May 9, 2011
U7-C-NINA-NRC-110075

South Texas Project
Units 3 and 4
Docket Nos. 52-012 and 52-013
Supplemental Response to Request for Additional Information

RAI 03.07.02-29, Supplement 1

RAI 03.07.02-29, Supplement 1**QUESTION:**

Figure 03.07.02-29 S1.1: Isometric View of the Box Structure (Element Aspect Ratio 1:1), Indicating the Nodes of Interest on Long Wall, Short Wall and Roof

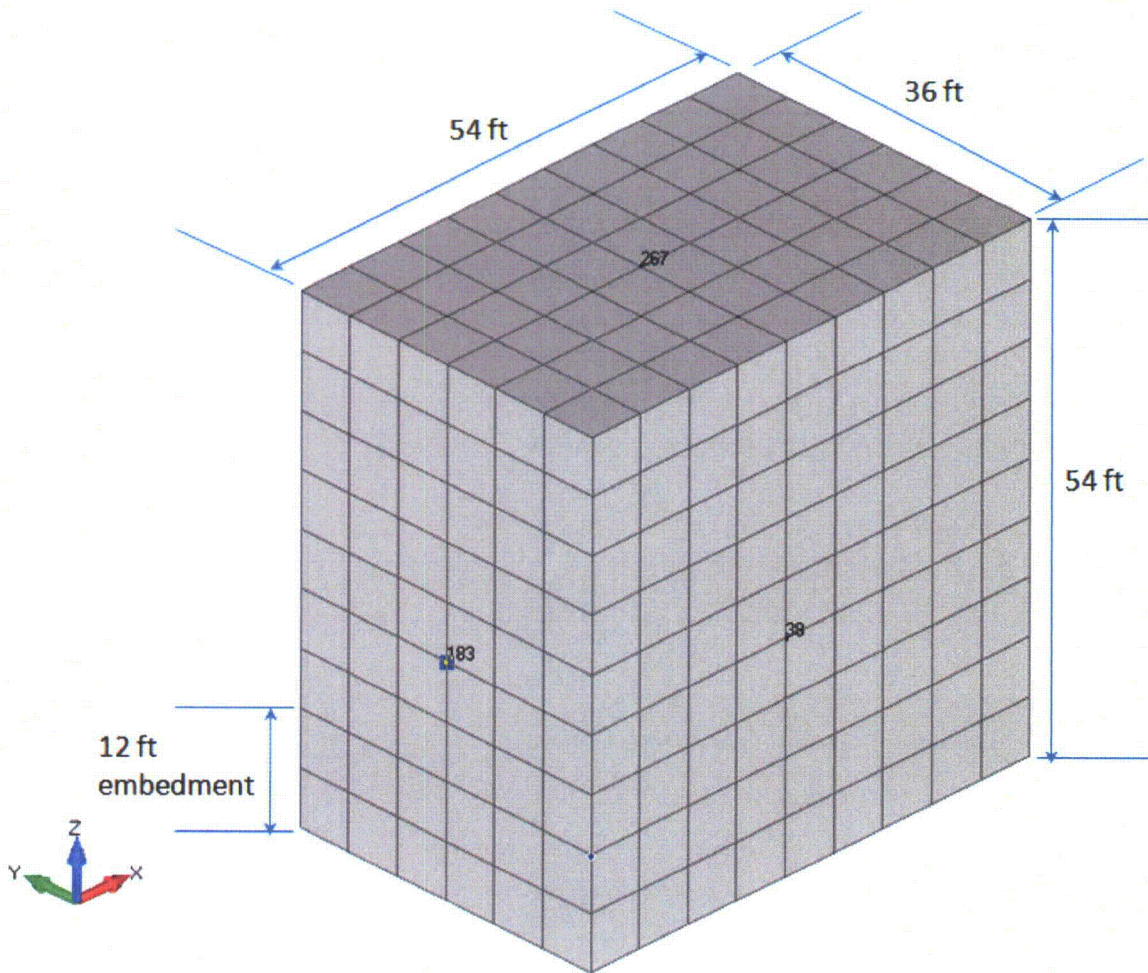
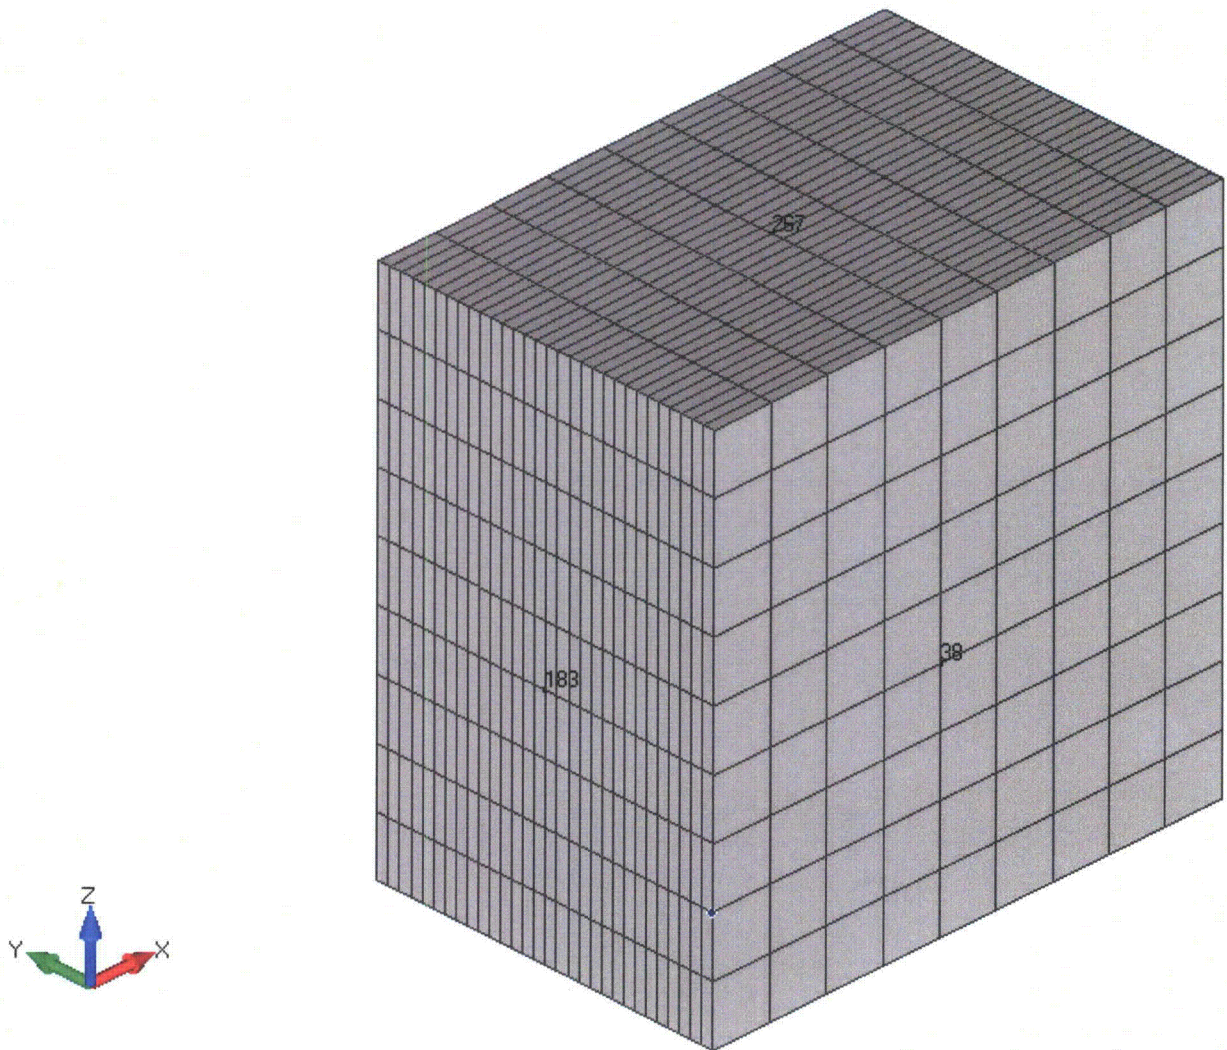
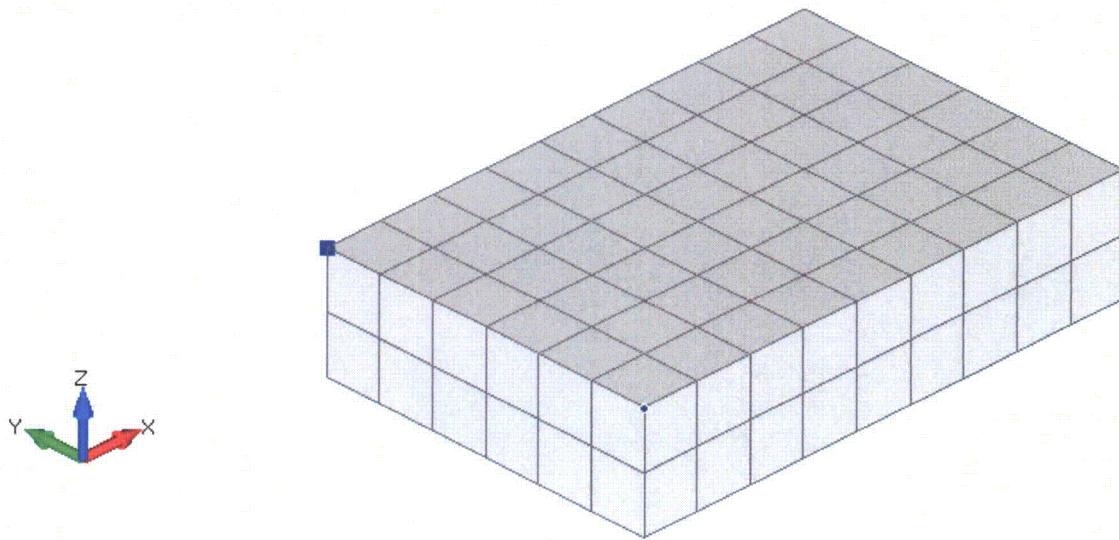
- For the S&L SASSI2000 aspect ratio test problem for two-way slab action, S&L was requested to provide transfer functions at the center of the roof slab for vertical excitation using the corresponding SGH model and considering very high soil shear wave velocity (rigid).
- For the SGH SASSI2000 aspect ratio test problem for two-way slab action provide transfer functions at the center of the roof slab for vertical excitation considering very high soil shear wave velocity (rigid).
- S&L was requested to add a cautionary note to the SASSI2000 release memorandum for users to examine transfer functions for any sign of instability.

As requested, the S&L aspect ratio test problem for two-way slab action was re-analyzed using the corresponding SGH model shown in Figures 03.07.02-29.68 through 03.07.02-29.70 provided in the Revision 1 response to this RAI which was submitted with NINA letter U7-C-NINA-NRC-110043, dated March 15, 2011. These Figures are presented as Figures 03.07.02-29 S1.1 through 03.07.02-29 S1.3 in this response.

For the aspect ratios of 1:1 and 1:5, the test problem is the same as shown in Figures 03.07.02-29 S1.1 and 03.07.02-29 S1.2, except that the excavation soil elements shown in Figure 03.07.02-29 S1.3 are changed to have shear wave velocity of 20,000 ft/sec (rigid soil). Other aspect ratio models (aspect ratios 1:2, 1:3 and 1:4) are constructed similarly

Figure 03.07.02-29 S1.6: Comparison of Response due to Vertically Propagating SV-Wave; Analysis Performed for Embedment Ratio = 0.5

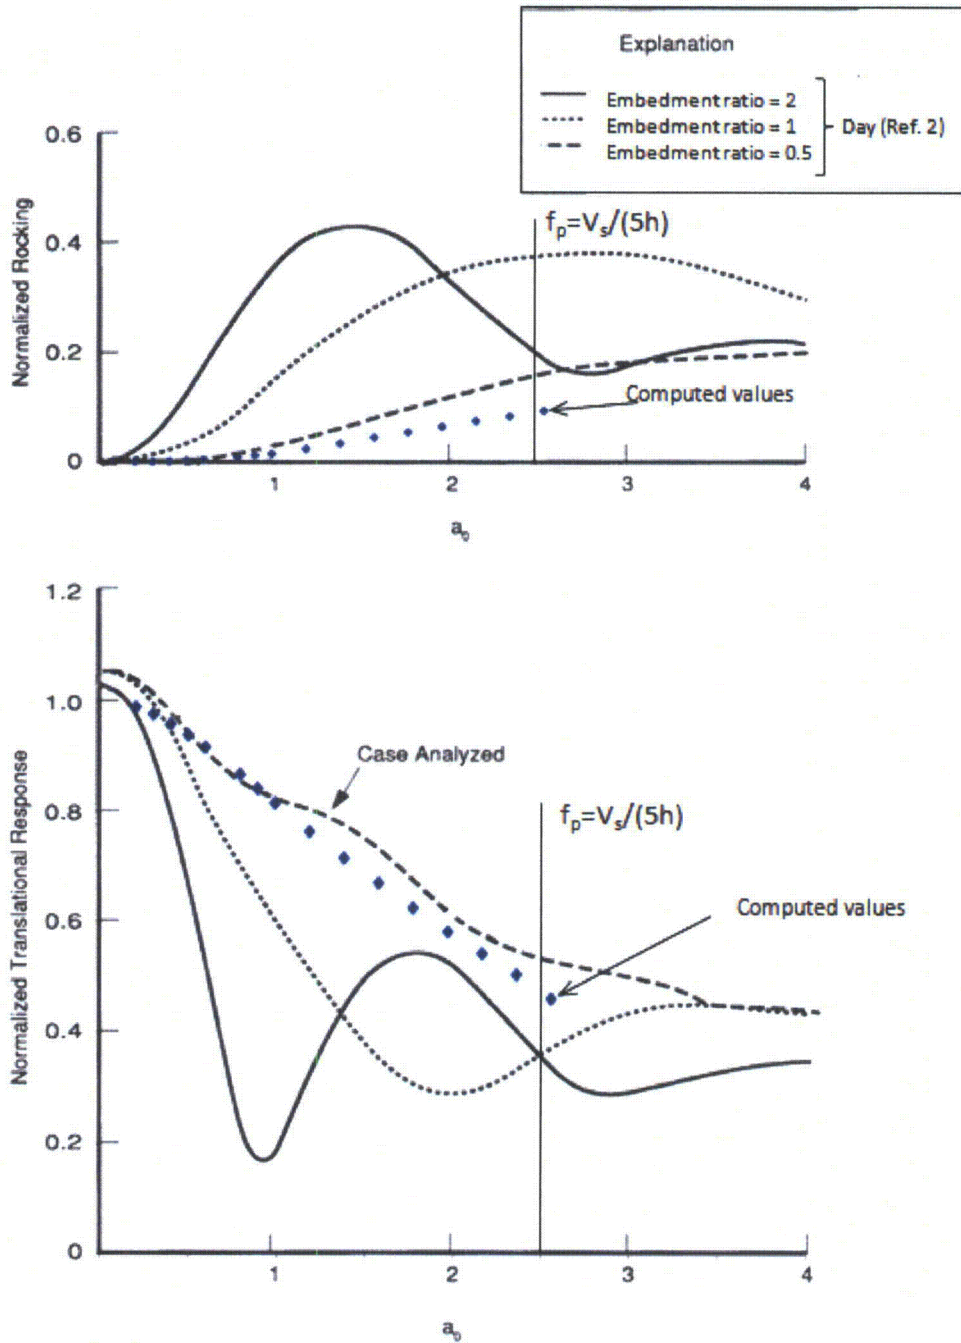
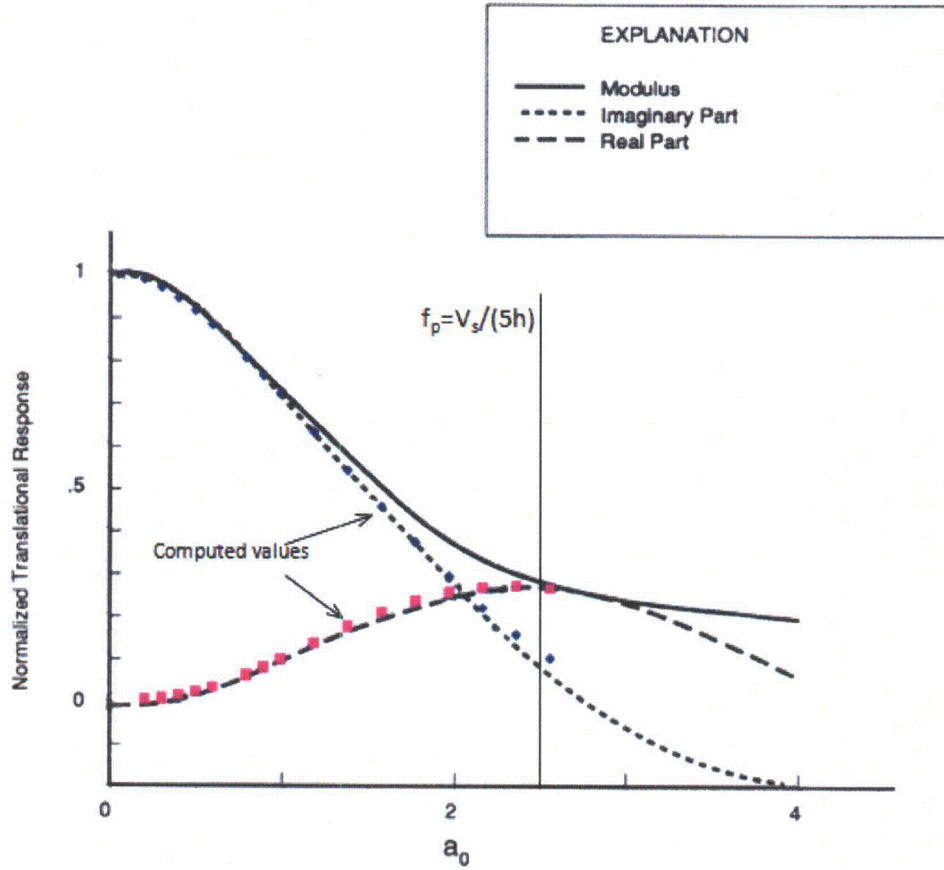
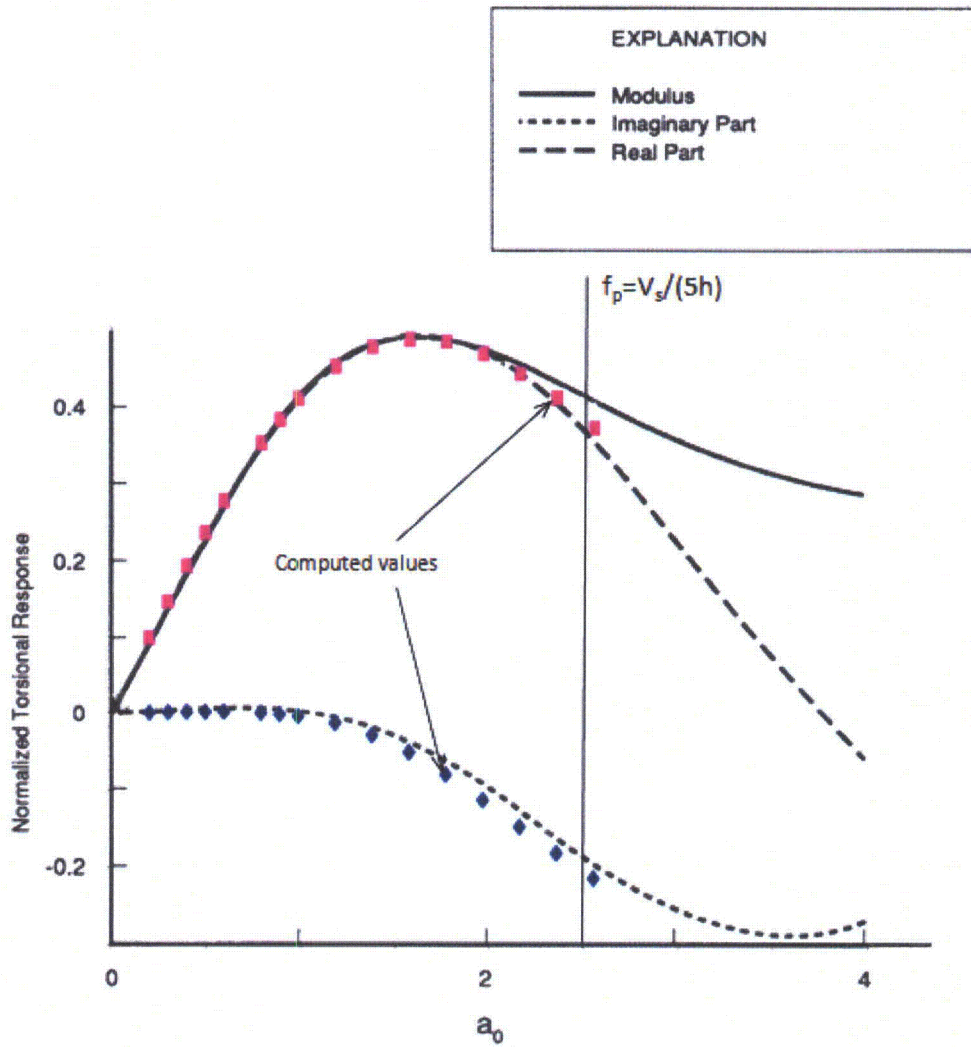
In reviewing the SGH SASSI2000 V&V of the subtraction method, it was found that the test problems (SAS-3C, SAS-4C and SAS-8) are not analyzed to sufficiently high enough frequencies that can validate the stability and accuracy of the subtraction method for passing frequency of $V_s/5h$, where V_s is the lowest shear wave velocity of the foundation media and h is the largest element size in the soil model. In the case of S&L SASSI2000 V&V Test problems 4 and 8 used in validation of the subtraction method, the analyses were carried out to sufficiently high frequencies to cover the passing frequency requirement of $V_s/5h$. However, the conclusion does not address the stability and accuracy of the subtraction method used in the context of the calculated results. In both cases, the applicant is requested to revisit the test problems and provide validation that adequately addresses the stability and accuracy of the subtraction method in relation to the acceptable passing frequency of $V_s/5h$ used in the STP 3&4 design.

In order to test the $V_s/5h$ passing frequency limitation, a similar problem of a circular embedded foundation over elastic half space was performed with a less refined mesh, such that the $V_s/5h$ passing frequency can be obtained with $a_0 < 3$. The example problem models a circular rigid foundation with a 64 ft radius, embedded 32 ft. The results demonstrate agreement with the theoretical solutions at all frequencies analyzed up to the $V_s/5h$ passing frequency, as shown in Figures 03.07.02-29 S1.6 through 03.07.02-29 S1.8.

The above test problem and test problem SAS-2A (Lotung model with 15 ft embedment) which was reviewed by the NRC staff during the March Audit, show the adequacy of the $V_s/5h$ passing frequency for subtraction method and running the additional equivalent test examples of SAS-3C and SAS-8 are not needed.

Figure 03.07.02-29 S1.9: Comparison of Generated Acceleration Time Histories from SAP2000 and ANSYS Programs for 6 ft Thick Slab Using Thick Shell Elements

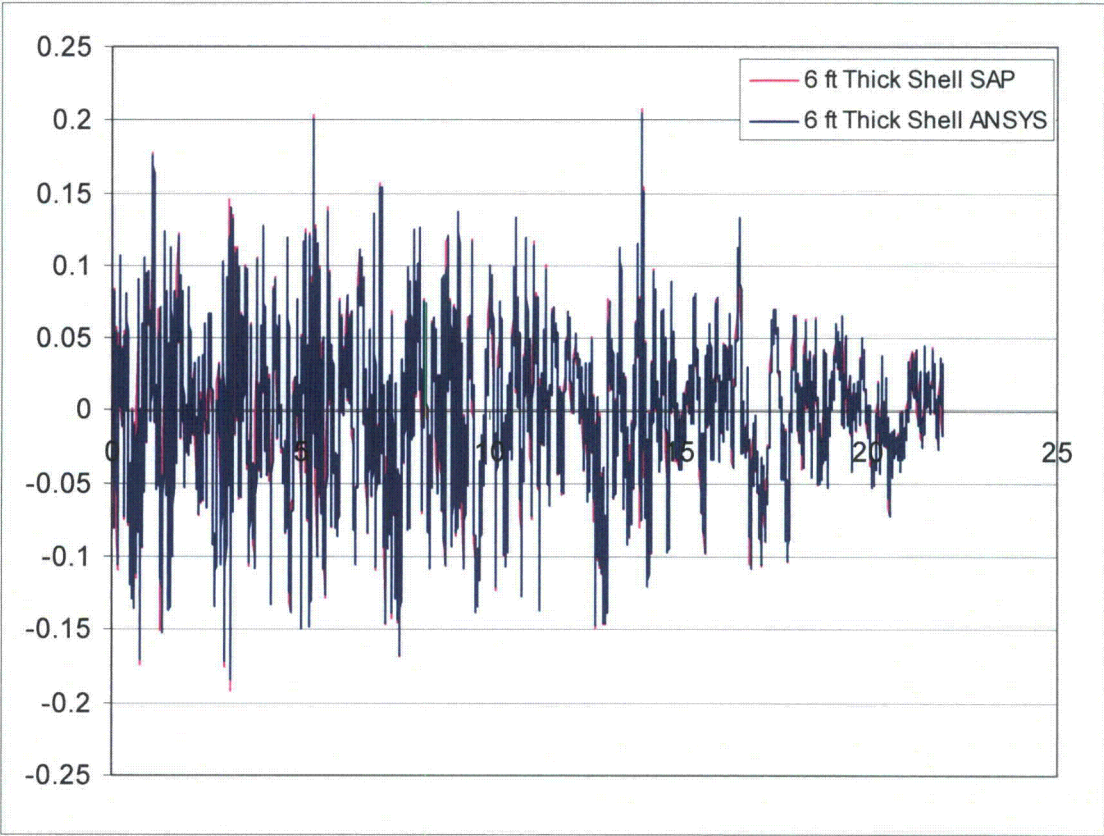
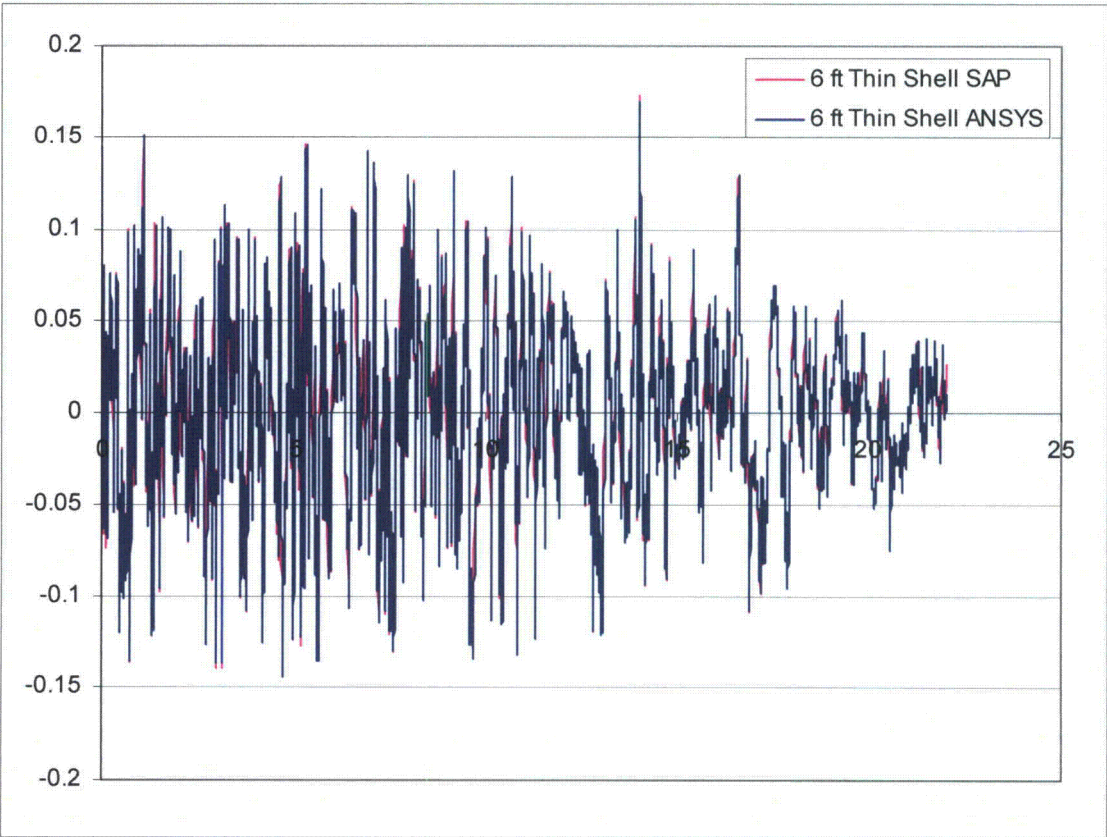
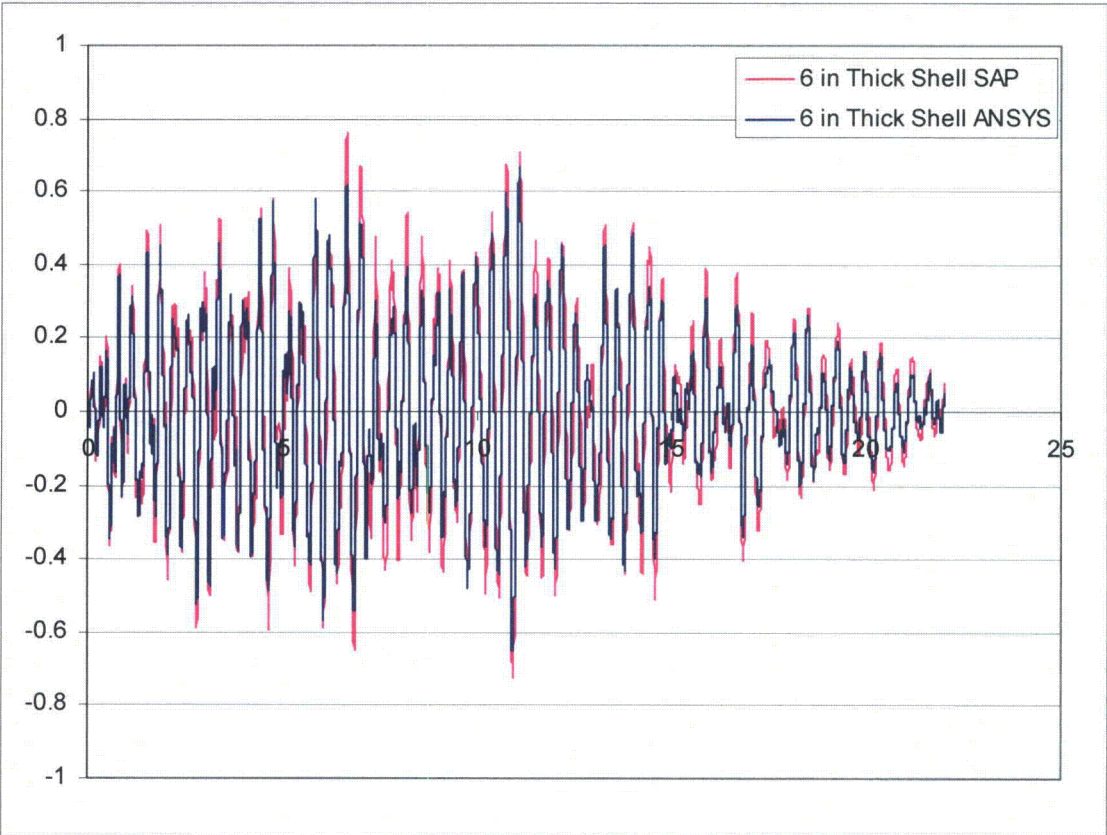
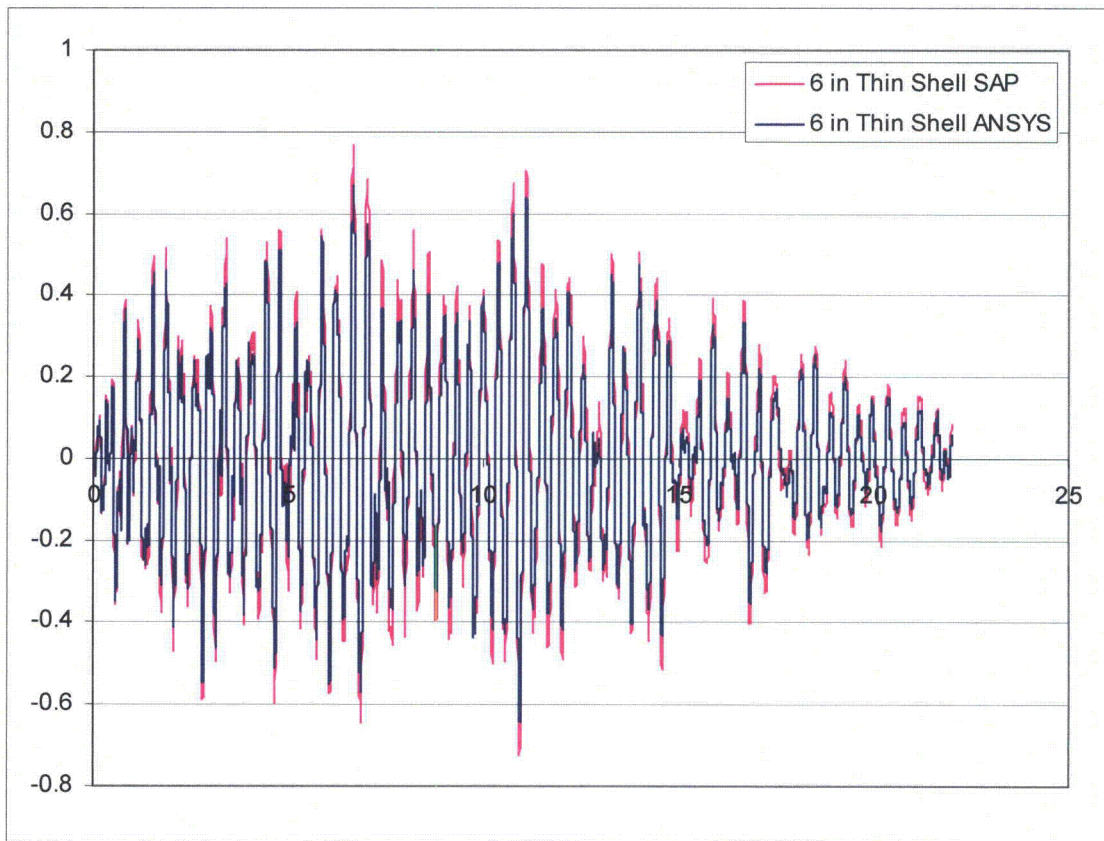
Validation of item "1" was done by hand calculation. For items "2", "3" and "4", the benchmark solutions for validation were developed with ANSYS utilizing "SHELL43" element, which is well suited to model linear, warped, moderately-thick shell structures according to ANSYS User's Manual. For items "2", "3" and "4", the following acceptance criteria were used: 5% for frequencies, 10% for forces, and 15% for spectra. The 5% difference is considered acceptable within the engineering accuracy, while the 10% and 15% criteria may be excessive. The applicant is requested to assess the impact of the above acceptance criteria on the STP 3&4 design.

The higher difference in forces and spectra is mainly due to differences in the SAP2000 and ANSYS element formulations. As a result of these differences, the generated acceleration time histories from the two programs are somewhat different. Figures 03.07.02-29 S1.9 through 03.07.02-29 S1.12 show the comparison of the generated acceleration time histories.

The forces and spectra generated from the SAP2000 program application used for the mesh sensitivity study are not used for design. Therefore, the above acceptance criteria have no impact on STP 3&4 design.
